The Heavy Hitter

BHS Assembly

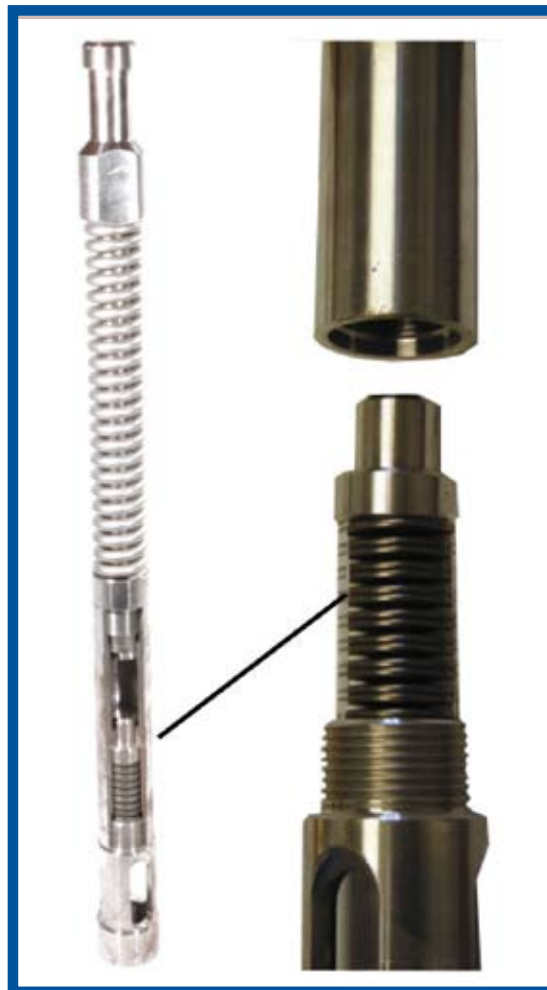
- **Old compression rate of 265 psi/in² : Total compression of coils equaled ~800**
- **New style is about 3 inches less of inconel coil, but more travel per square inch at 310 psi/in².**
- **This is accomplished by adding the bellville washer kit in the cage, giving the spring a total compression rating of 3100 psi/in².**
- **The spring is designed to engage ~70% of the washer pack for total compression**
